## 11302 FIRMWARE REPLACEMENT

11302      All Serial Numbers

## MANUAL CHANGE INFORMATION

Date: 18-Jan-90 Change Reference: M70209 Rev-1

**Figure 2. - EPROM locations, Main Processor ckt bd A11**

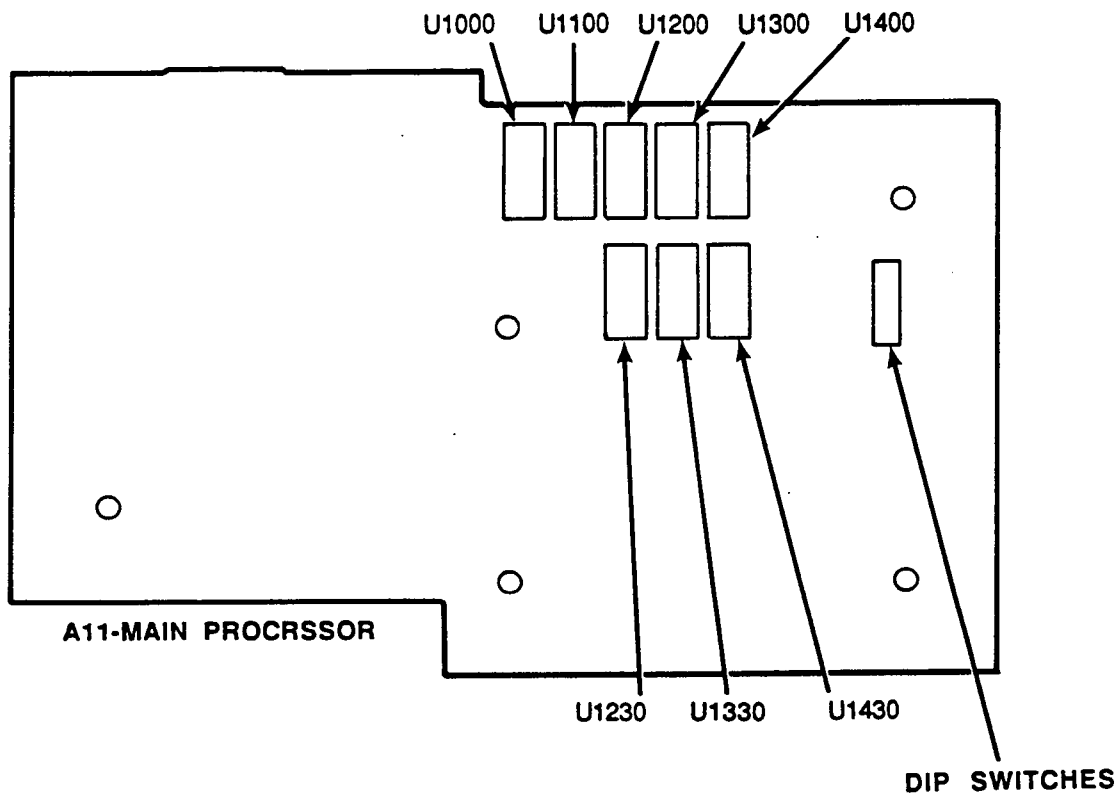
- 3. Replace U1000, U1100, U1200, U1230, U1300, U1330, U1400, and U1430 with the new EPROM's that are provided in this kit. Refer to Figure 2, for EPROM locations.

Figure 2-74. Measurement choices shown above.

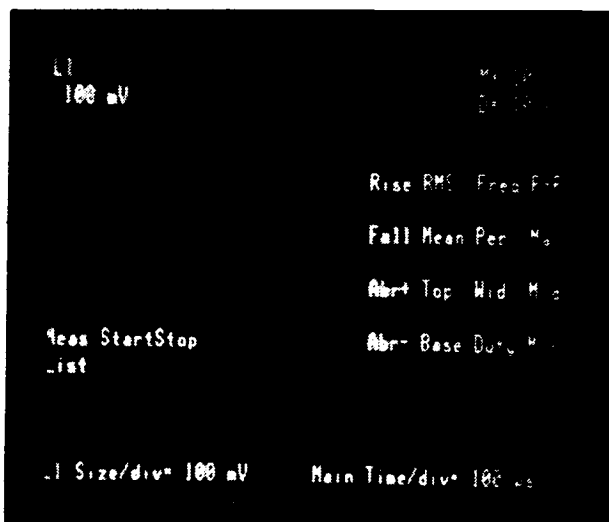
Add this new display to page 2-151:

The MEASURE major menu display has been changed as shown below:

Figure 2-79. Non-volatile stored settings menu selections.

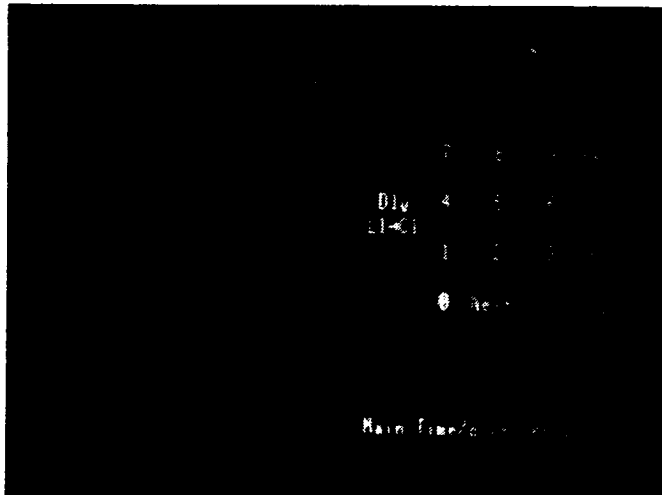
Add this new display to page 2-162:  
The STORE RECALL major menu display has been changed as shown below:

## STORE AND RECALL MENU

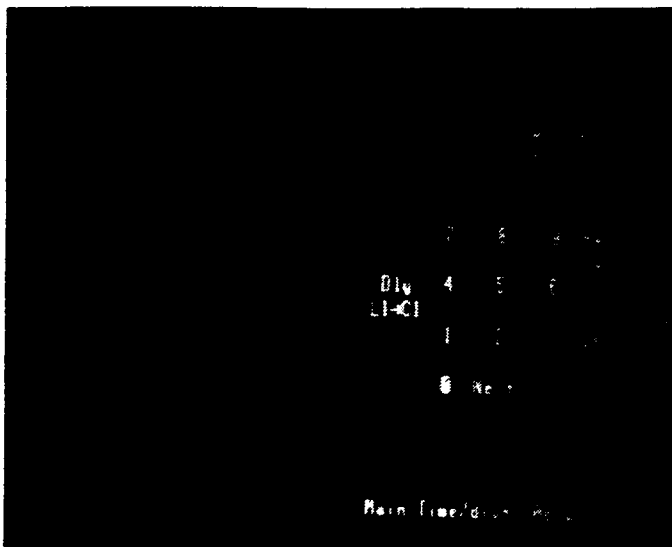
Add this new feature to page 2-162, 070-6106-00  
Add this new feature to page 2-163, 070-7175-00

New Feature:  
**Dly**  
**L1—»C1**

When L1—»C1 is selected on the store recall menu the scope will automatically setup to measure prop delay between signals on the left CH 1 and center CH 1. When this command is initiated the present scope setup will be lost.
